Colorado Springs, CO
Planning and Development

Final Report - Corrections Required
Application No. DEPN-22-0222

Description : A new 53 unit apartment complex
Address : 0 8th ST Colorado Springs CO 80905
Record Type : Development Plans
Document Filename : Development Plan Set

GENREAL INFORMATION

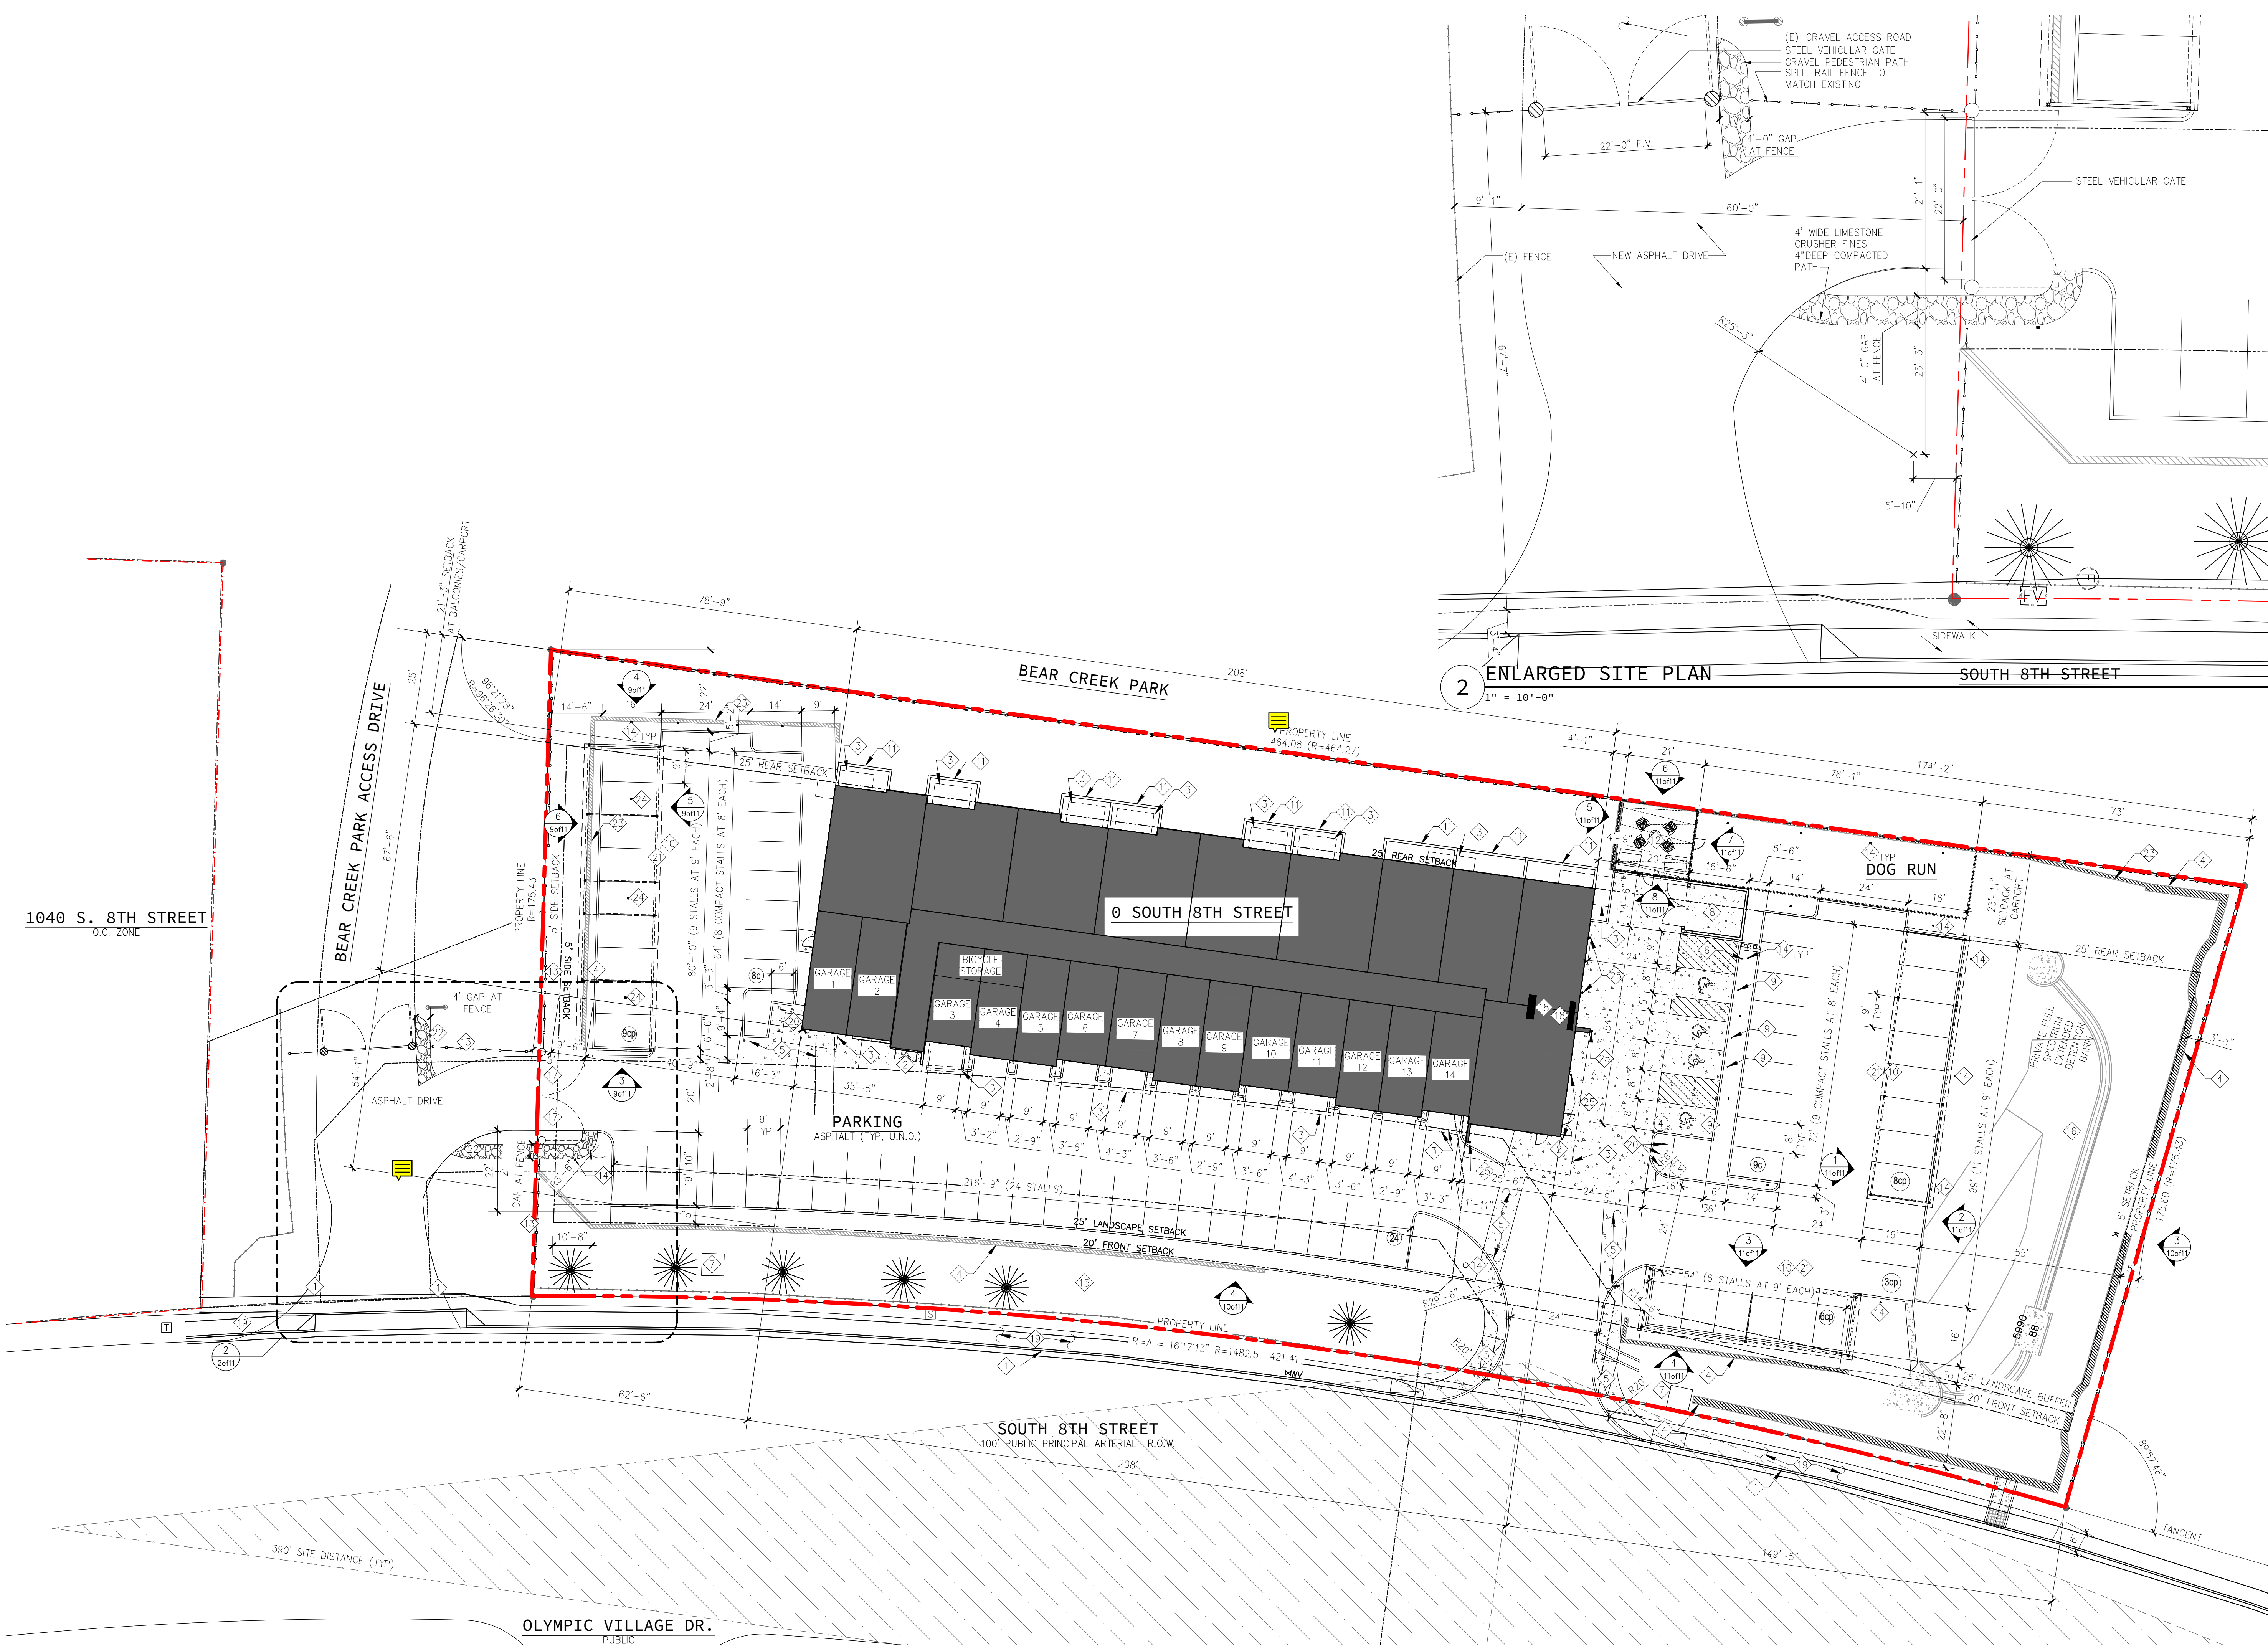
Include the flood zone in the Floodplain Note on the cover sheet (e.g. Zone X).

FIRM panel number should read 08041C0729G.

FINAL LANDSCAPE PLAN

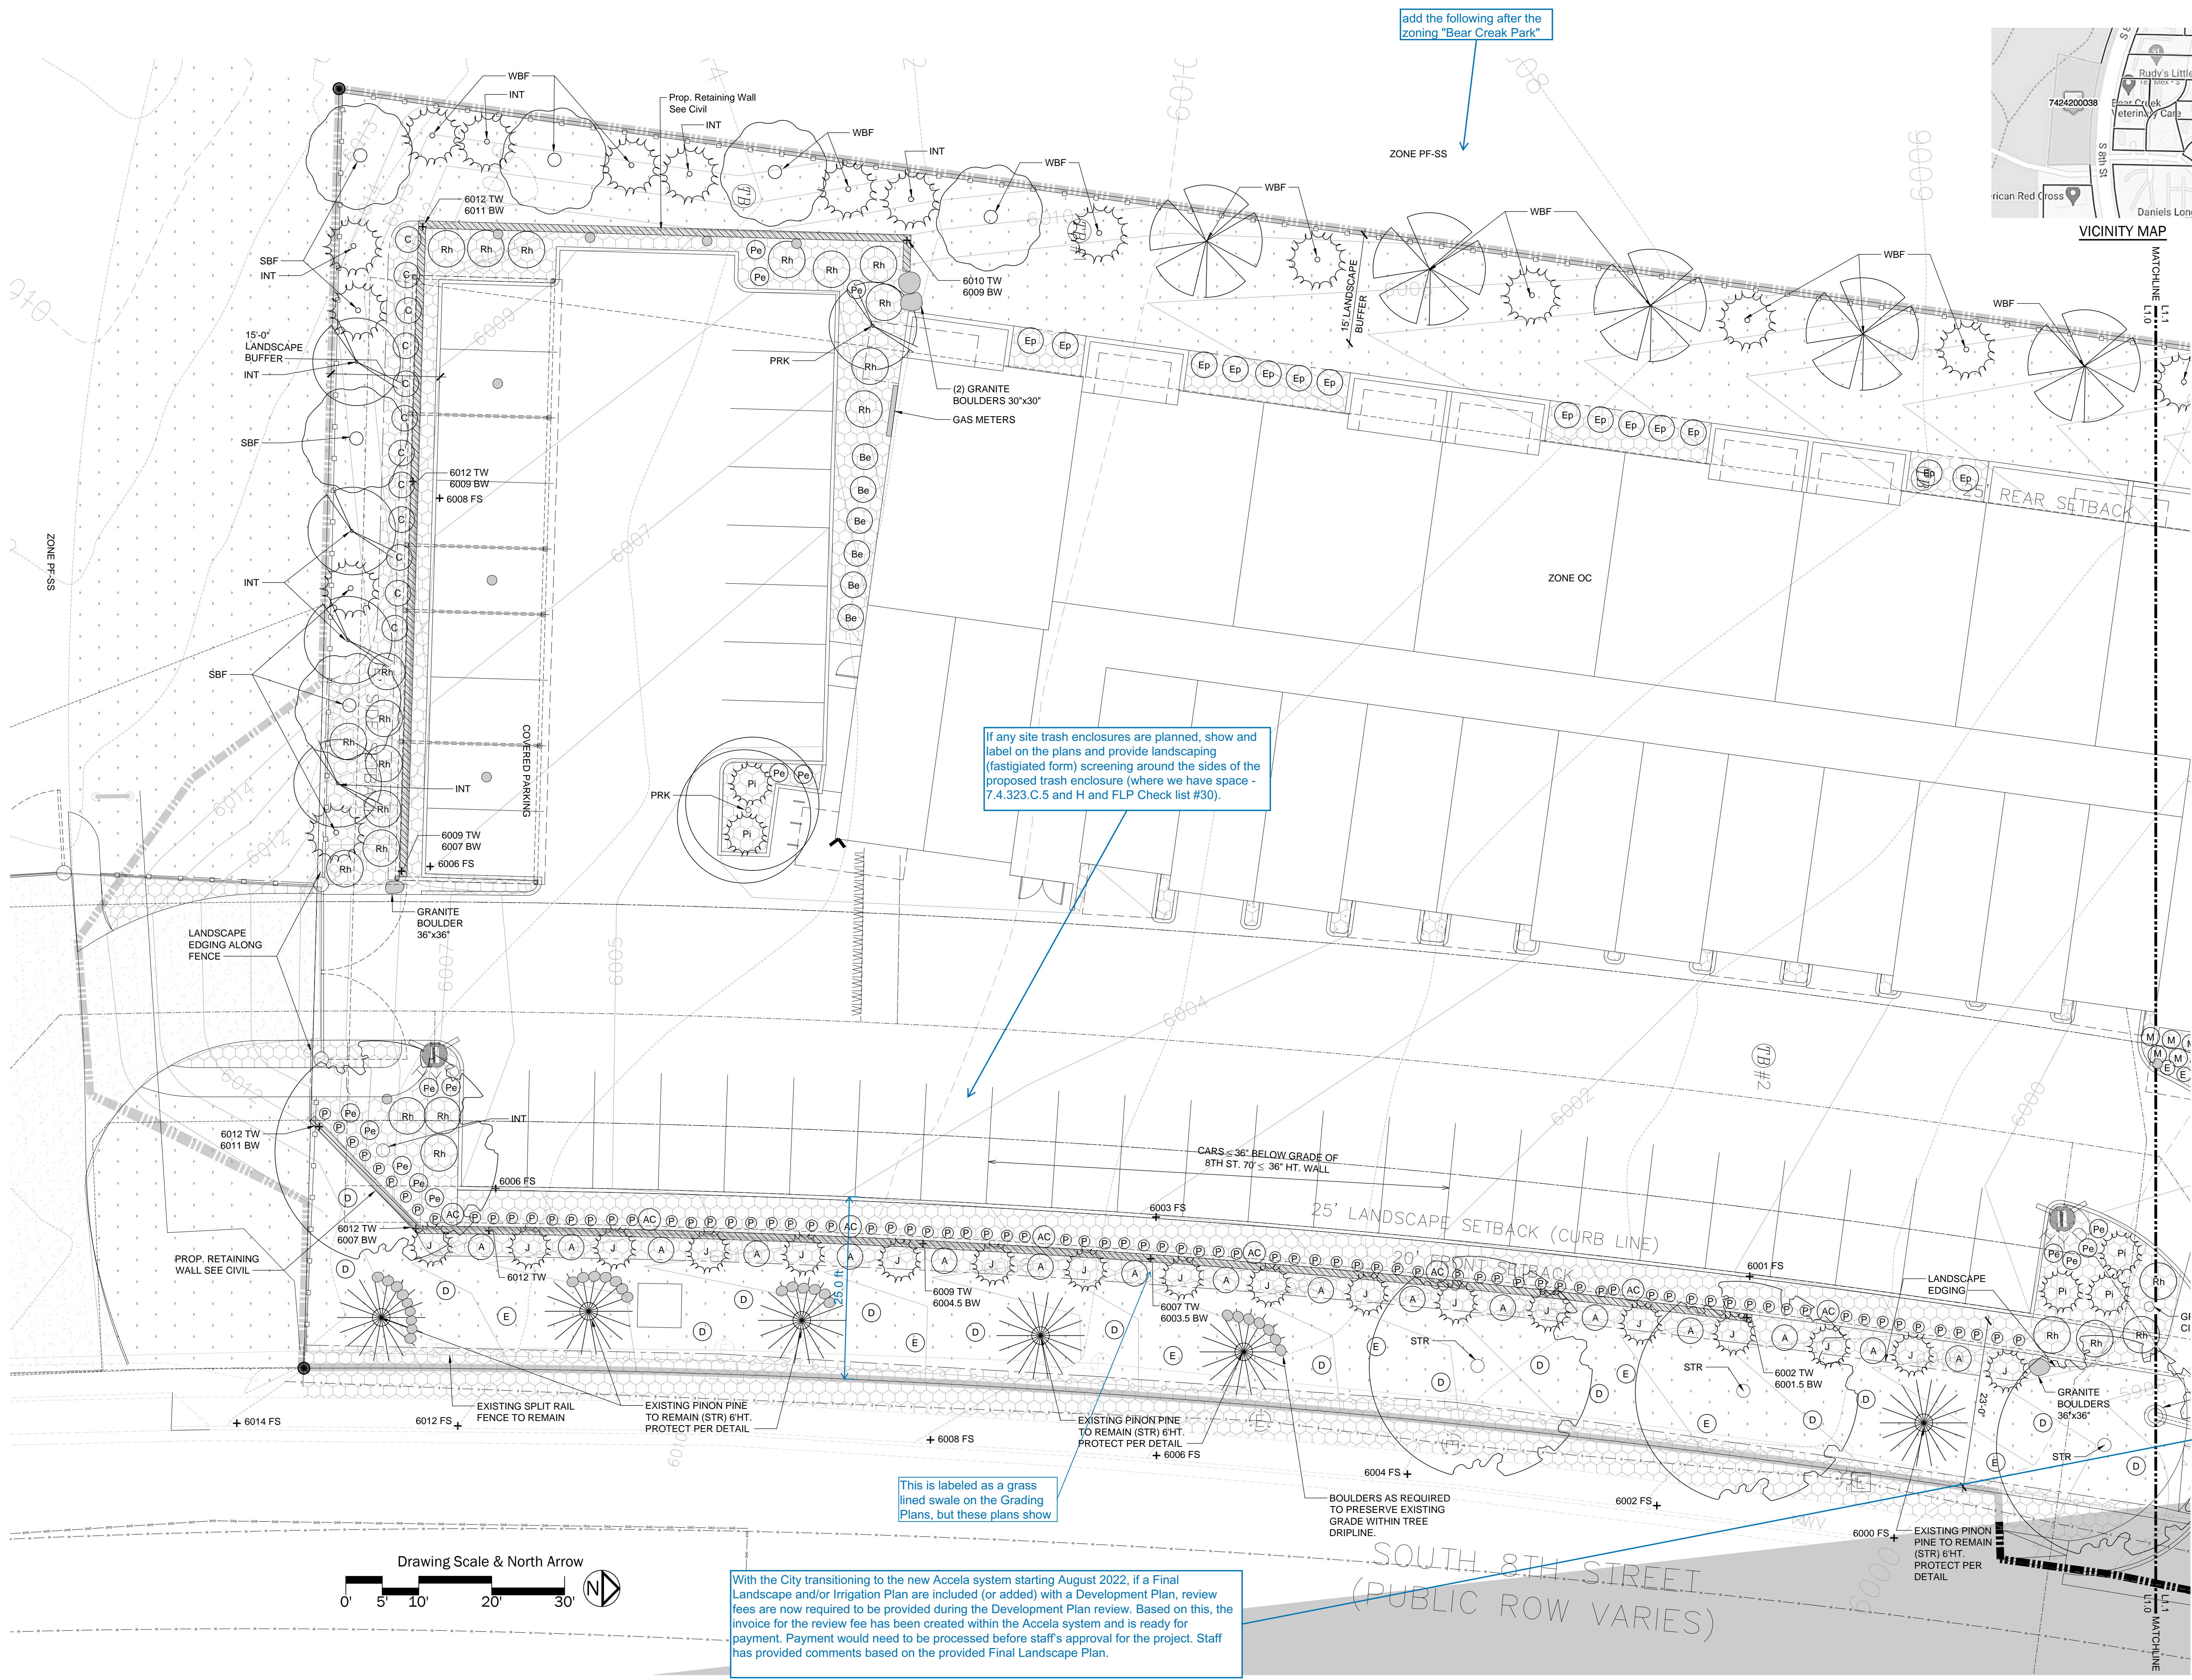
add the following after the zoning "Bear Creek Park"

If any site trash enclosures are planned, show and label on the plans and provide landscaping (fastigiated form) screening around the sides of the proposed trash enclosure (where we have space - 7.4.323.C.5 and H and FLP Check list #30).

This is labeled as a grass lined swale on the Grading Plans, but these plans show

With the City transitioning to the new Accela system starting August 2022, if a Final Landscape and/or Irrigation Plan are included (or added) with a Development Plan, review fees are now required to be provided during the Development Plan review. Based on this, the invoice for the review fee has been created within the Accela system and is ready for payment. Payment would need to be processed before staff's approval for the project. Staff has provided comments based on the provided Final Landscape Plan.

Confirm the total amount of provided trees, staff is getting 65, revise the plans as needed.

FINAL LANDSCAPE PLAN

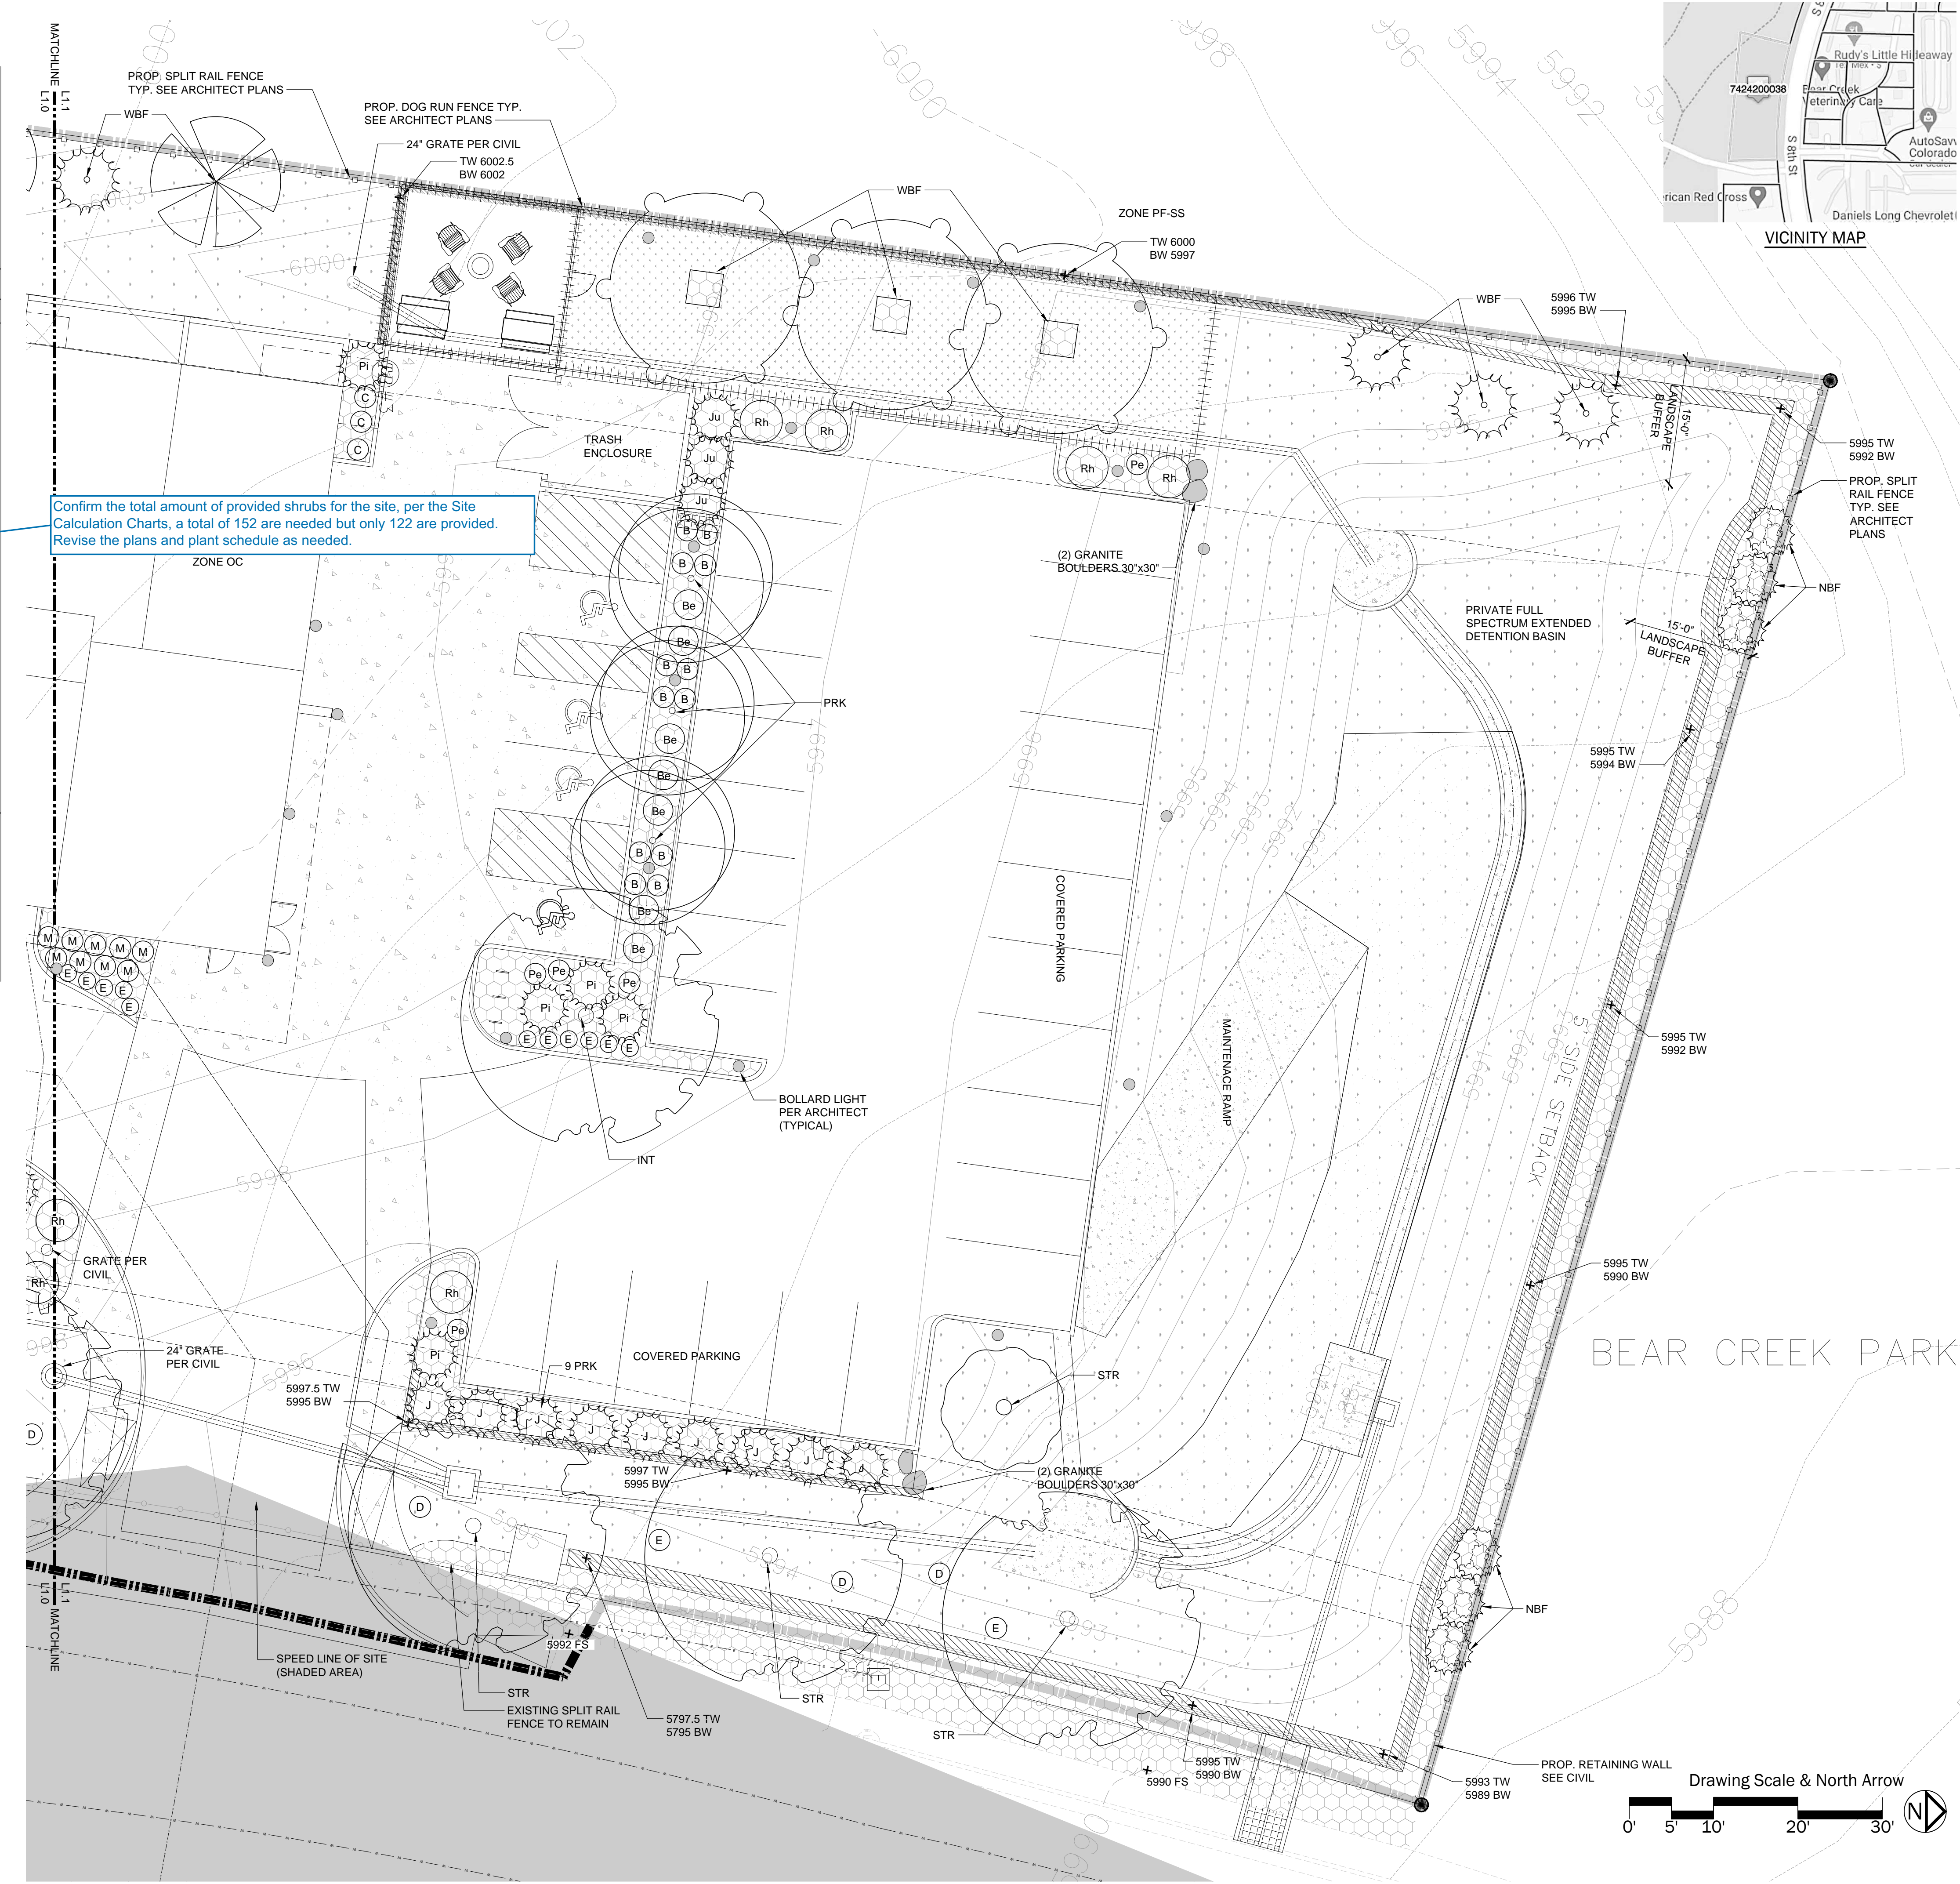
Confirm the total amount of provided shrubs for the site, per the Site Calculation Charts, a total of 152 are needed but only 122 are provided. Revise the plans and plant schedule as needed.
